YAMAHA Technical Bulletin

15 March 1990

ITEM NO. TB105 **TZR250R (3MA) ENGINE TEMPERATURE PROBLEM**

FIG 1

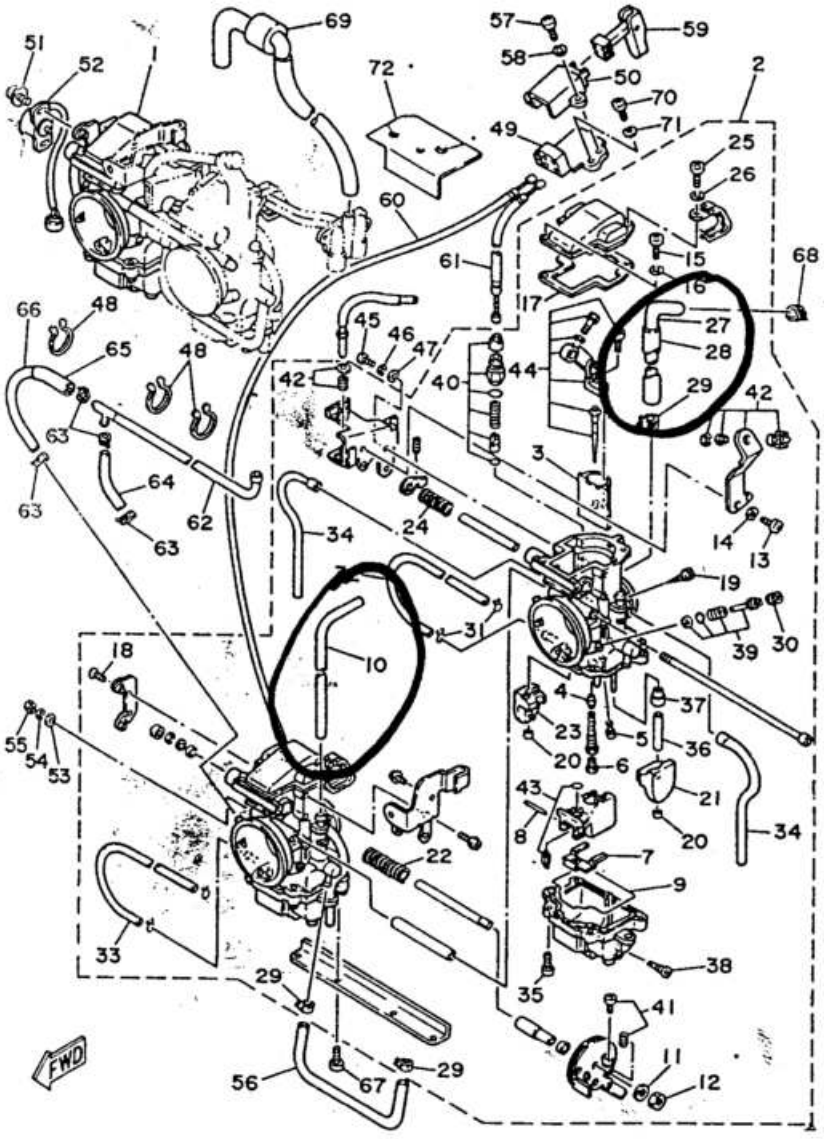
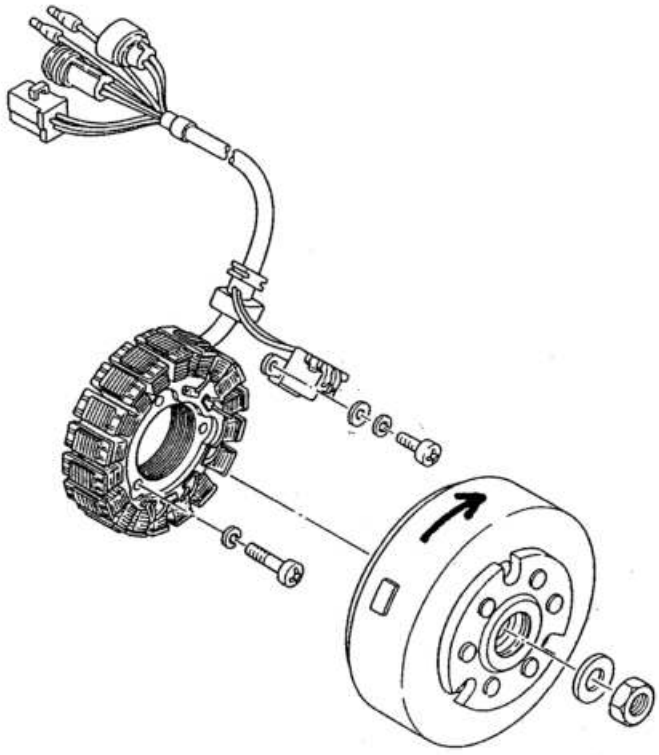
Hose 10 (2RH-12484-00) and Hose 27 (3MA-12483-00) interconnect "coolant" from the cylinder head to cavities in the carburetors.

Disconnect these hoses at the cylinder head and purge all coolant from out of the carburetors. Instal in each hose a 5/16" ball bearing and reconnect to the cylinder head.

The effect of this modification is to lower intake charge temperature, especially on the RH cylinder.

FIG 4

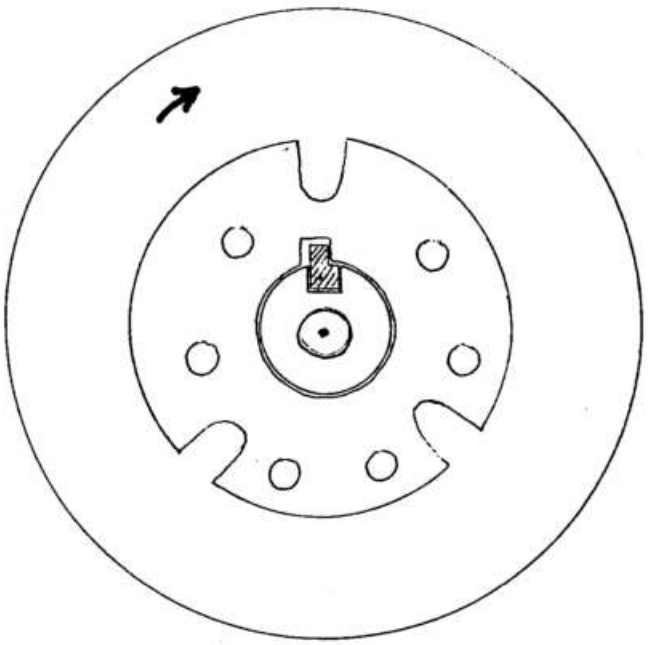
Reassemble the flywheel and key exactly as depicted, retarding the flywheel anticlockwise against the direction of engine rotation. This will ensure that the RH side of the flywheel keyway slot abuts against the cutout face of the key.

Torque the flywheel nut to spec and remove it again. With a torch double check the assembly position is correct. Refit and re-torque the nut.

FIG 5

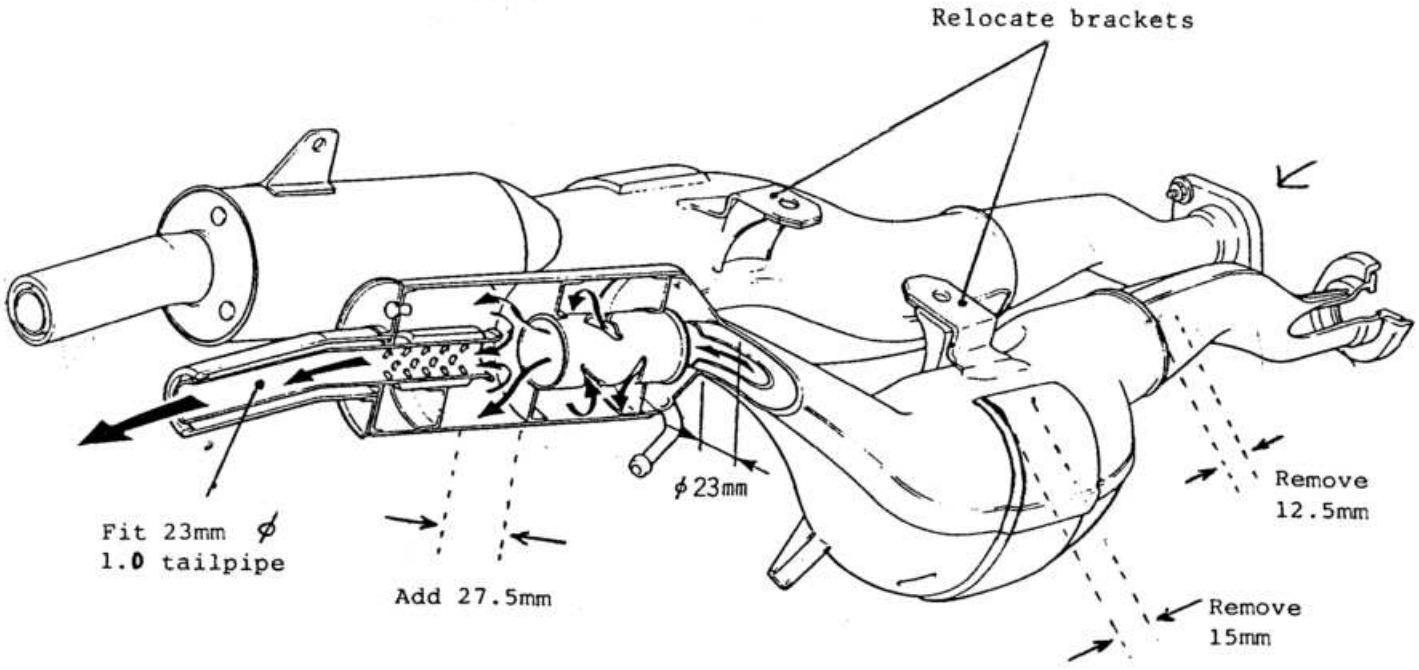
Assessed against exhaust port opening angle, the standard pipes are very long in tuned length expressed as the distance between piston exhaust thrust face and an imaginary point halfway along the reflection cone of the exhaust. We shortened the overall tuned length by removing two sections as depicted. We also replaced the rearmost tailpipes with larger internal diameter pipe to reduce piston crown temperature.

These pipe modifications had a major effect on carburation requiring corrective adjustments to both carburation and the air compensator assembly.

FIG 7

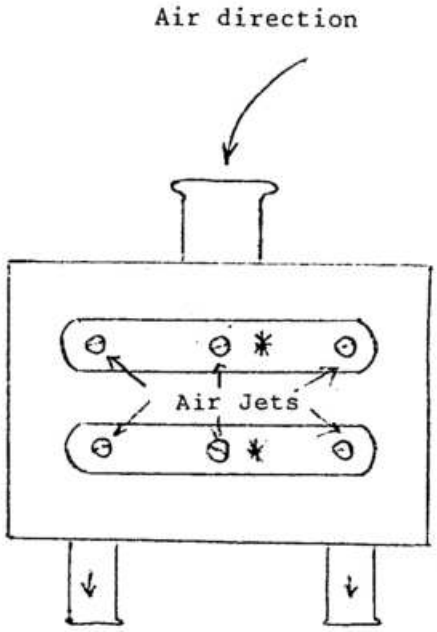
Central airjets in air compensator (denoted by asterisks * in Fig 7) enlarged to 1.0mm.

Carburation	Main jet	# 190	* Revised
	Power jet	# 20	
	Needle/clip position	6L02-63-2	
	Pilot jet	# 15	
	Nozzle	Q8	* Revised
	Fuel level	6mm	
	Float level	18.9 - 20.9mm	
	Airscrew	$2\frac{1}{4}$ turns
